Public Engagement Summary

0 Agnes Street - Alton Village, Town of Caledon

RE: Resident Comments Response Summary

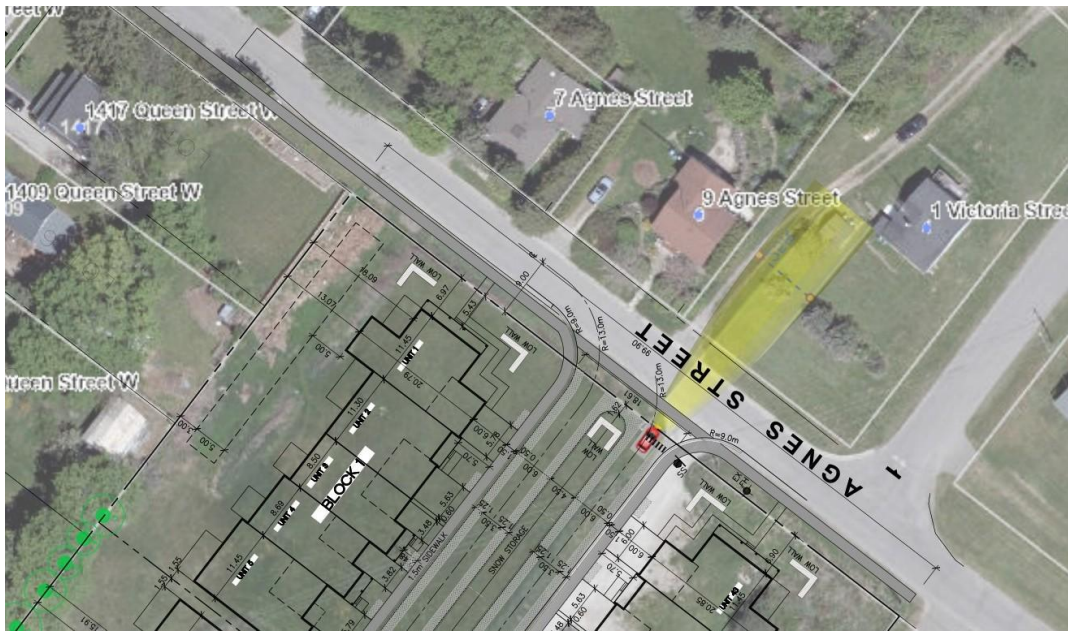
Will the Townhouses have basements?	The intent is to have basements where grades permit. Some blocks will be walk ups or walk-outs, meaning the basement level is at grade at the front or rear. See the first question in section 7 below that talks about soil testing and bedrock.
Alex Gaunt <i>(email correspondence dated March 29, 2024)</i>	We were told that the maximum height of the houses would be storey/storey and a half. And yet, Jordan got up and described how the plan would be to build three storey houses in blocks 7, 8, 9A.	We apologize for the inconsistency. The proposal calls for bungalows, bungalow with lofts and two-storey dwellings. Following the topography of the site, the units on the south side of the site (Blocks 7, 8 and 9A) are front walk-ups 3 storeys in the front facing into the interior of the site and 2 storeys in the rear facing the neighbours' rear yards. The garage and front door will be at ground level in the front, the main living area will be one floor up walking out

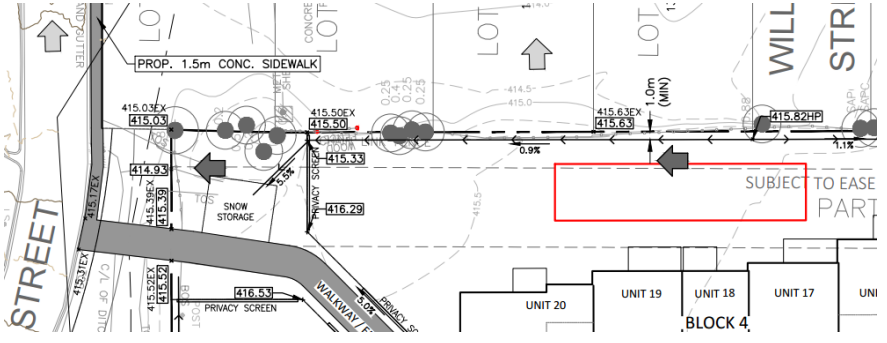
<p>There is an easement that runs behind my property from Agnes to Emeline. How is it that septic systems are allowed to be put in the easement.</p>	<p>Arrangements are underway with Hydro One to relocate the power line from the easement on private lands to the public Right of Way at the developer's expense. This is preferred by Hydro One and the Town in any event. The easement will then be abandoned and will therefore not impact the septic systems or other services and buildings.</p>
<p>Nicolette and Gary Crowther</p>	<p>We have significant concerns related to septic systems for the proposed townhomes, with 3-5 townhouse units sharing septic systems, and the possibility</p>	<p>Please see Section 4 of the Resident Response Letter and the separate Sewage Systems Info Package for a detailed description</p>

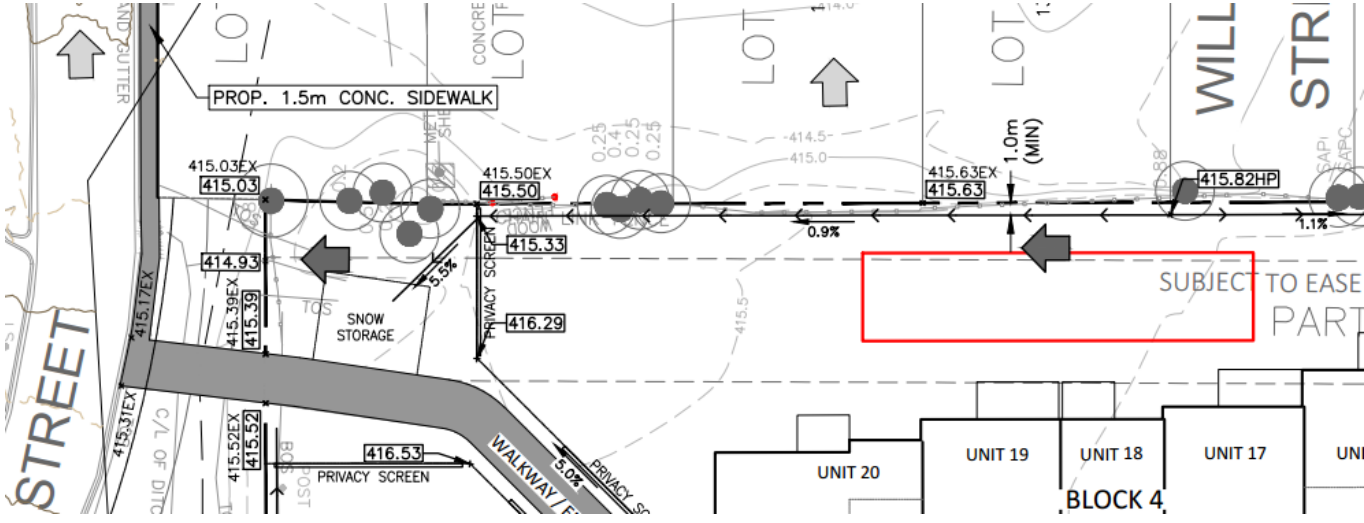
4. Sewage Systems		
Name	Comment	Response
	<p>within the parameters provided in this development proposal, they need to have this system investigated, to ensure our safety and quality of life.</p> <p>Our group of concerned ALTON RESIDENTS would like to meet with the person who has, or will approve the use and implementation of these septic systems for 14 Agnes Street.</p> <p>NOTE: I contacted Waterloo Biofilter and spoke with André Suvron approximately two weeks ago, regarding these septic systems. I asked for the location of a comparable development to 14 Agnes Street, where these systems had been installed. I was not provided with one. He informed me that "normally, a single townhouse has its own septic system."</p> <p>André Suvron also stated that "they calculate septic capacity on number of bedrooms, rooms, and square footage; they do not count basements."</p> <p>On Monday afternoon, April 22nd, Marianne Willson of Waterloo Biofilter phoned me to discuss my concerns.</p> <p>She stated that Waterloo Biofilter is "just selling these systems", like "buying a sink somewhere, and they also carry out the maintenance of these systems."</p> <p>Marriane stated that, "Waterloo Biofilter Septic Systems is not engaged in those documents".</p> <p>(referring to the number of septic systems, and dwellings on the proposed development at 14 Agnes Street).</p> <p>I was then told that the Planning Engineers, Development Engineers, and Design Engineers, were the ones to speak to in order to find information pertaining to the efficacy, and any problems encountered with these septic systems on other</p>	<p>Englobe has completed groundwater characterization for the property including completion of monitoring wells to determine depth to groundwater, groundwater flow direction, groundwater quality, including impacts to groundwater from upgradient properties to consider the cumulative impact of sewage disposal downgradient of the site. As part of the investigation completed by Englobe treatment targets were established for effluent to meet acceptable impacts both at the downgradient property limit, and to Shaws Creek. The results of the Englobe investigation have been peer reviewed by a third-party licence engineering firm on behalf of the Town.</p> <p>The septic system design completed by Gunnell Engineering incorporated the design requirements specified within the Englobe report, and Waterloo Biofilter was engaged since their technology is approved under the Ontario Building Code and capable of meeting identified treatment targets.</p>
